NORMANDY HEIGHTS - PRD

PTN OF THE SE 1/4, OF THE SE 1/4 OF SEC. 35, T 20 N, R 4 E, W. M.
CITY OF PUYALLUP, PIERCE COUNTY, WASHINGTON

Sheet Title:
COVER SHEET

Sheet Title:
MASTER SITE PLAN

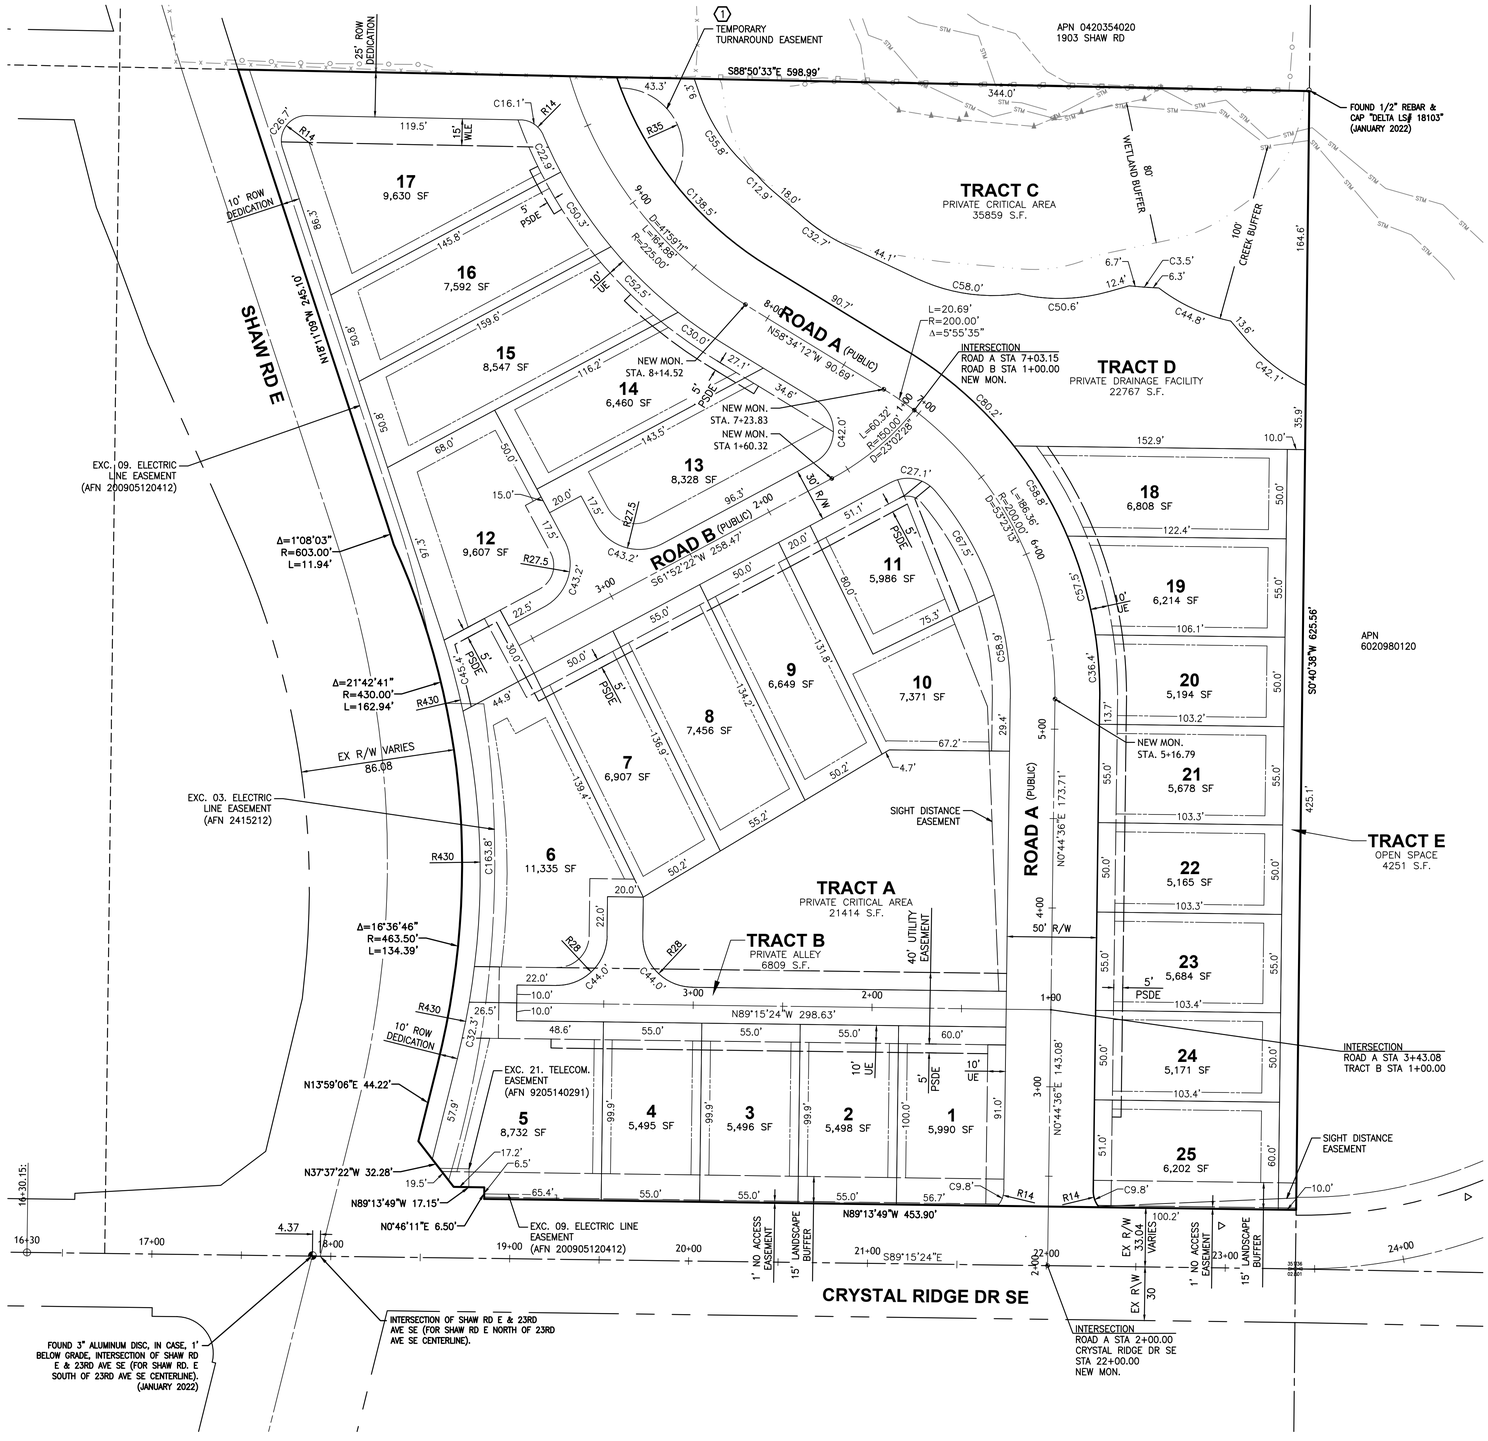
Parking sign layout (throughout plat) does not meet City standards. Please review standard detail 01.04.05 for placement and mounting angle requirements. NO PARKING signage standard detail not provided in civil plan set.

Define height of solid board fence, see PMC 20.20.040 for fence standards, see PMC 20.15 for definitions of front, rear, interior, and other property sides. Also, it is hard to see where the fence begins and ends along Crystal ridge Dr SE. Revise to clearly indicate where fence begins and ends

Sheet Title:
TESC SITE NOTES AND DETAILS

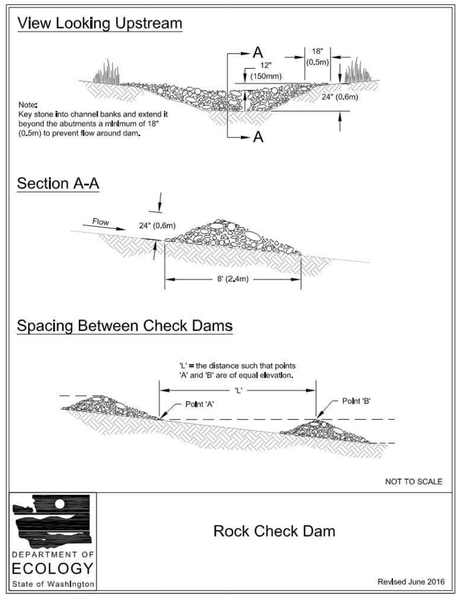
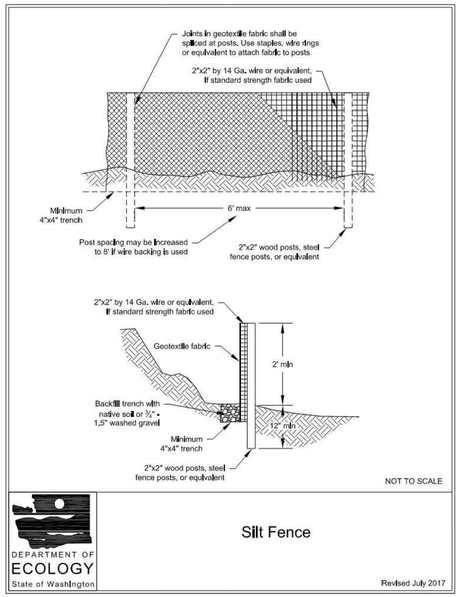
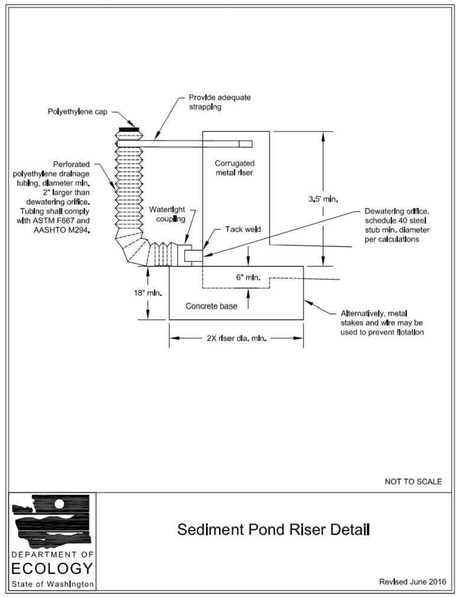
Add Tree protection detail to sheet 6

OVERALL WATER SYSTEM PLAN

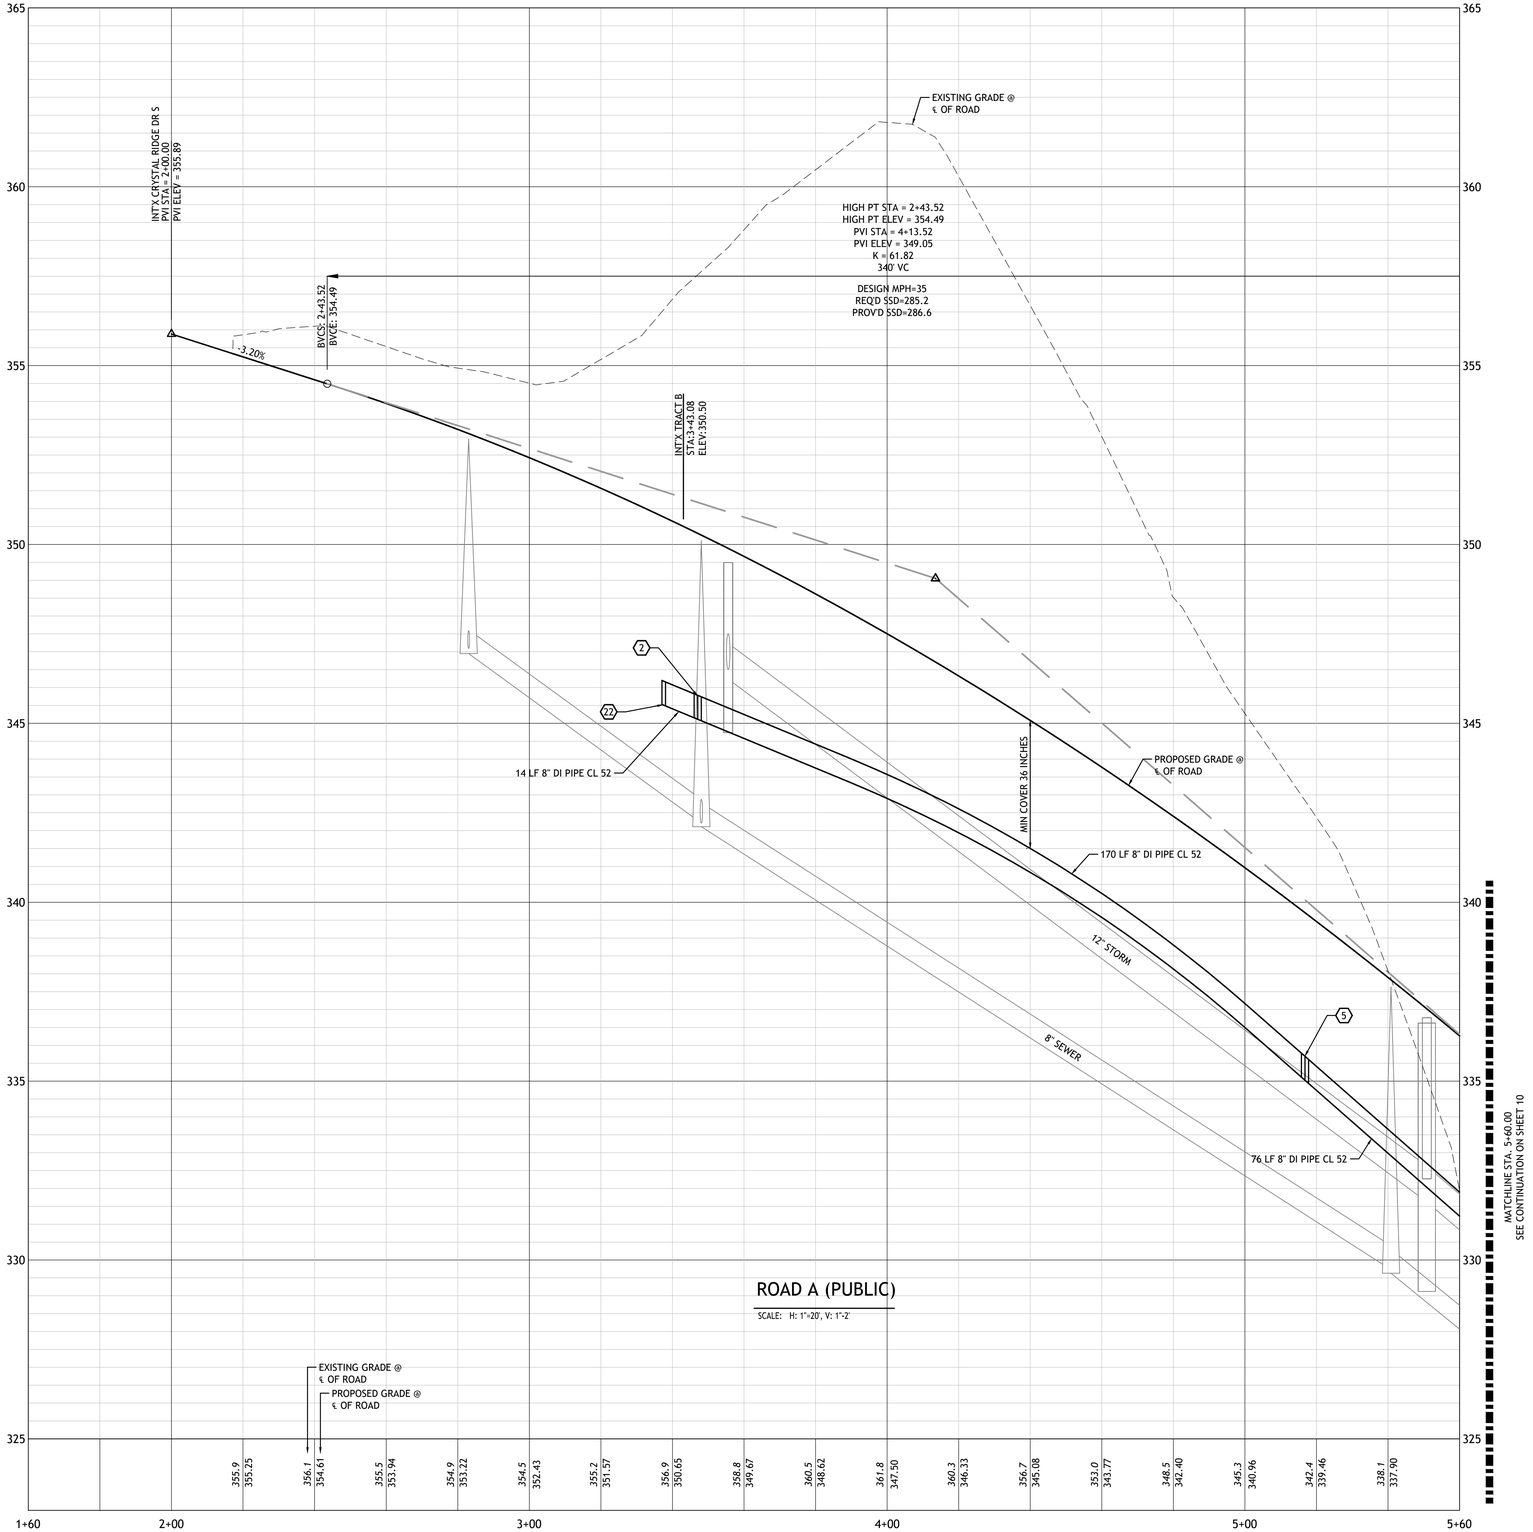
Due to the elevation change on Road 'B', an air relief vault will need to be installed at the west end of the 4-inch water main. Add city standard detail 03.07.01 Air / Vacuum Valve to this plan set. To be able to flush this 4-inch water main, a 2-inch blow-off assembly will need to be installed at the end of the 4-inch water main west the air relief vault. Add city standard detail 03.06.01 2" Blow-Off Assembly to this plan set.

PRV vault size and equipment must match existing PRV station that will be getting abandoned.
32. CONNECTION TO THE EXISTING WATER MAIN USING WET TAP THROUGH A TAPPING TEE AND TAPPING VALVE. CITY APPROVAL REQUIRED PRIOR TO MAKING CONNECTION. 1-8" TAPPING TEE 1-6" TAPPING VALVE 12 LF OF 6" DI PIPE CL 52 1- FIRE HYDRANT ASSEMBLY, SEE DETAIL 44. W/ CONCRETE THRUST BLOCKING

CRYSTAL RIDGE DR SE ENTERING SIGHT DISTANCE

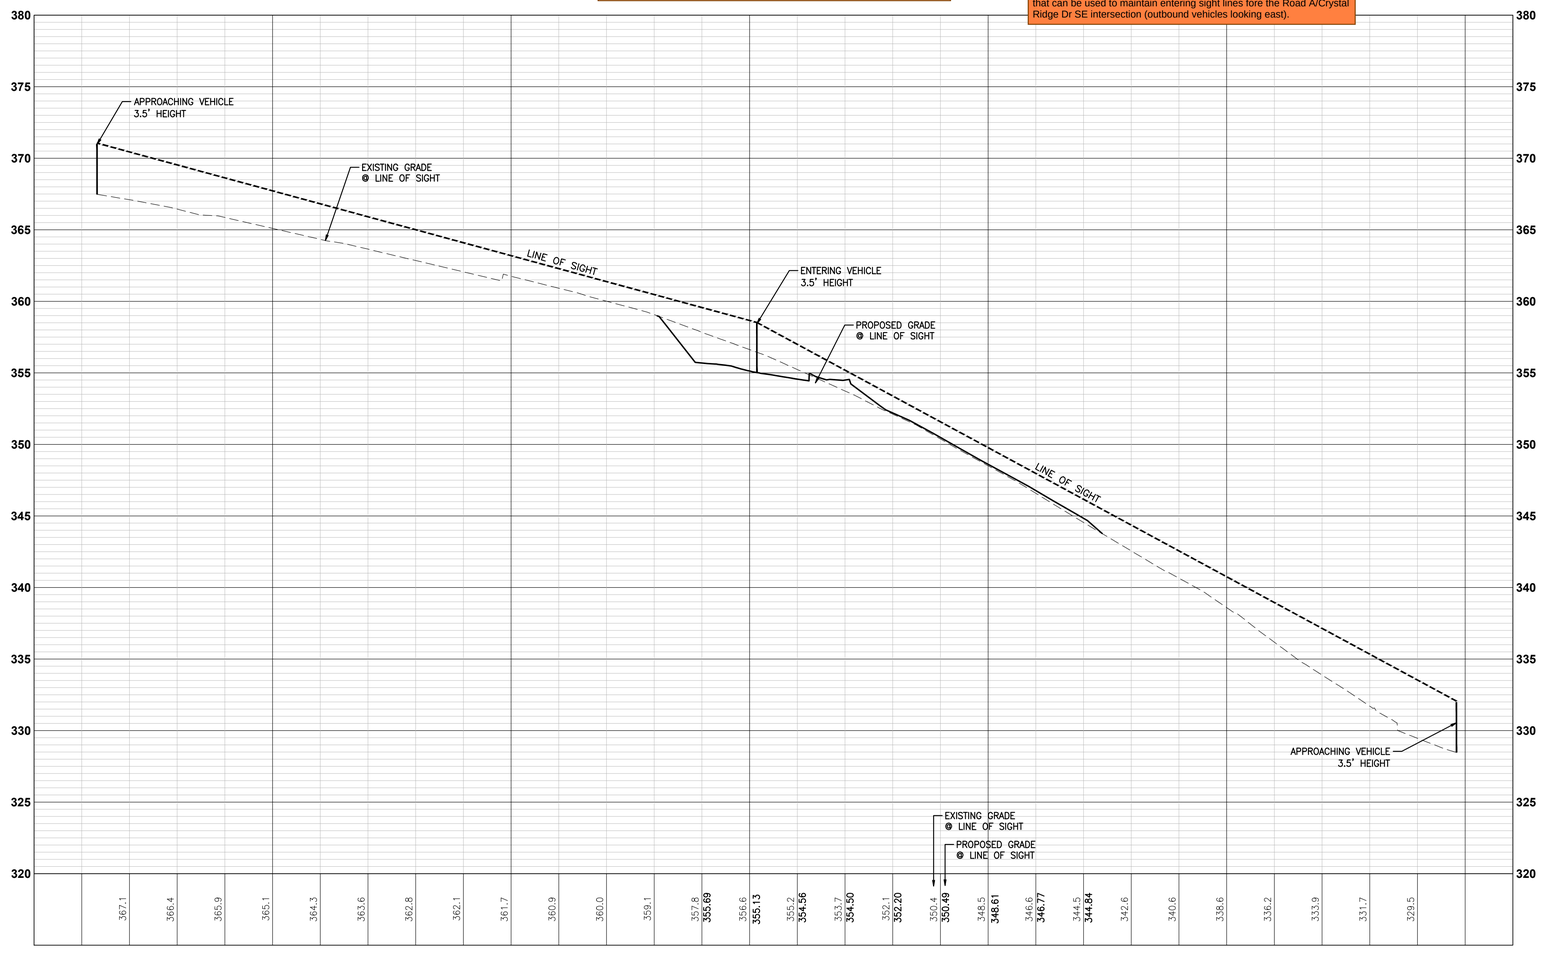
Possible that existing trees can be limbed up 7ft to meet sight distance requirements. Place a note on plans that sight distance to be verified by Puyallup engineering staff to determine if existing trees can remain or be removed.

Per PSP approval conditions, draft sight distance easements must be submitted with civil submittal. Please include existing City easement documentation along the Crystal Ridge Dr SE frontage (adjacent parcel) that can be used to maintain entering sight lines fore the Road A/Crystal Ridge Dr SE intersection (outbound vehicles looking east).

TRACT B (PRIVATE) - ENTERING SIGHT DISTANCE

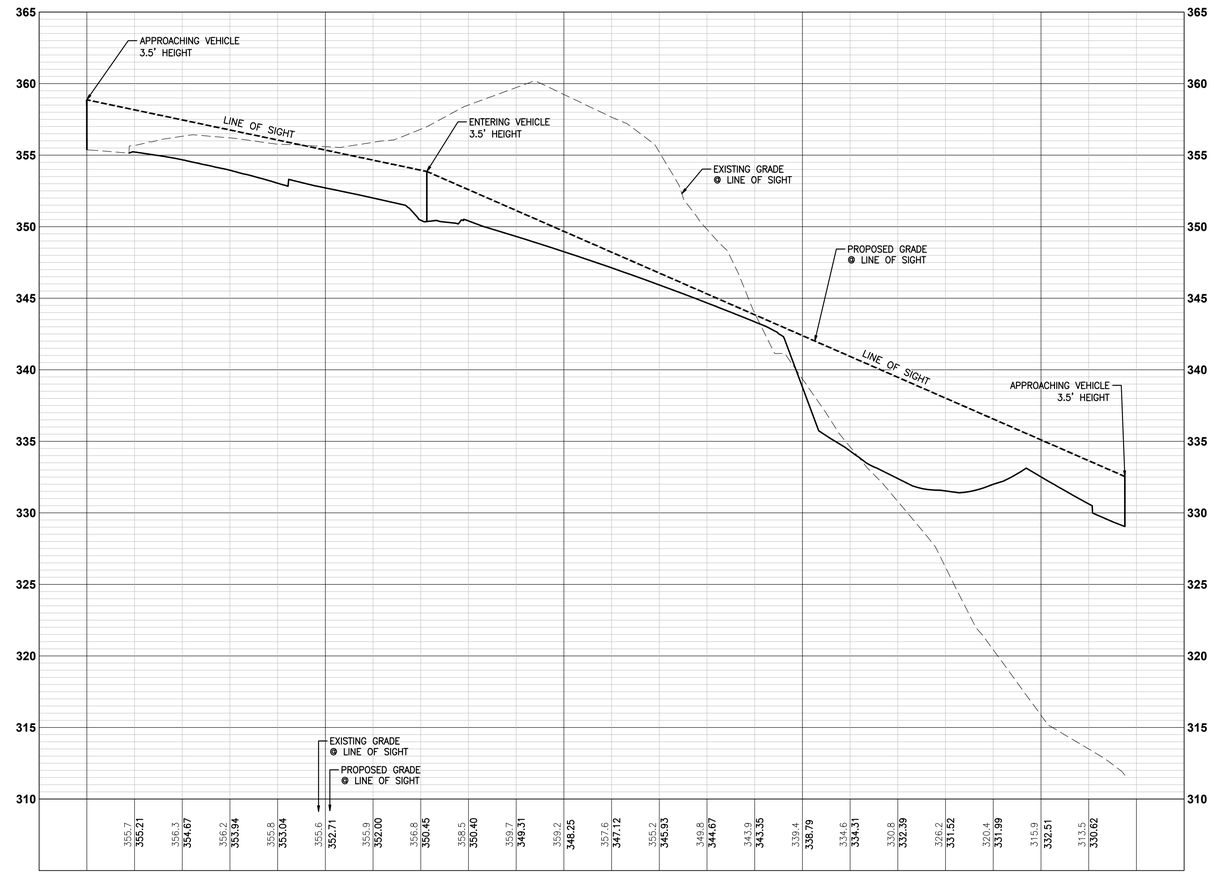
Per PSP approval conditions, draft sight distance easements must be submitted with civil submittal.

ROAD B (PUBLIC) - ENTERING SIGHT DISTANCE

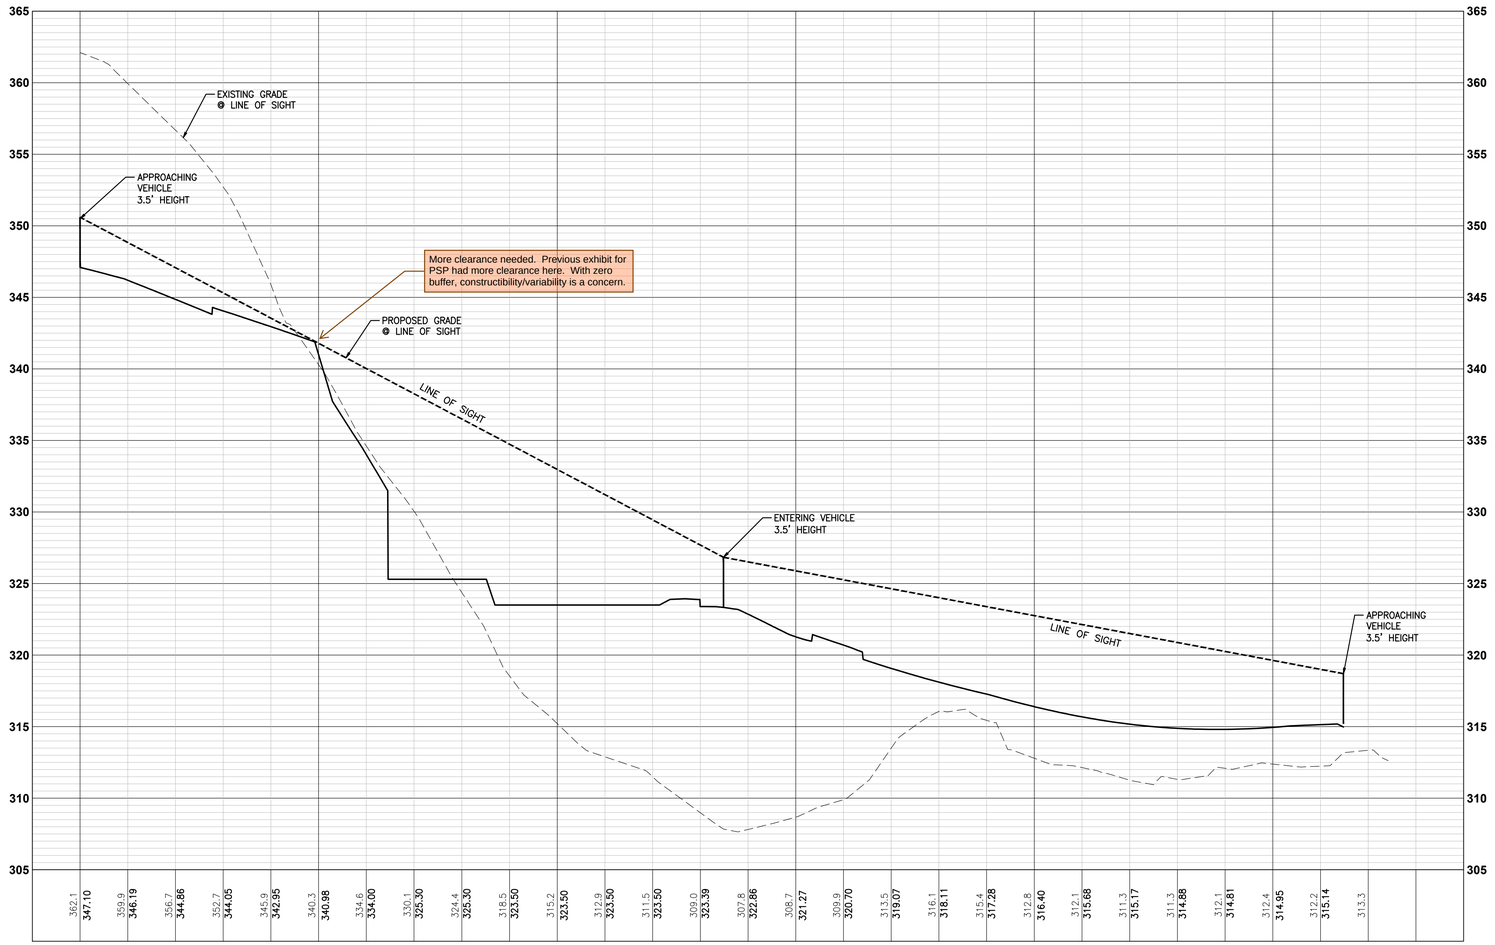
Per PSP approval conditions, draft sight distance easements must be submitted with civil submittal.
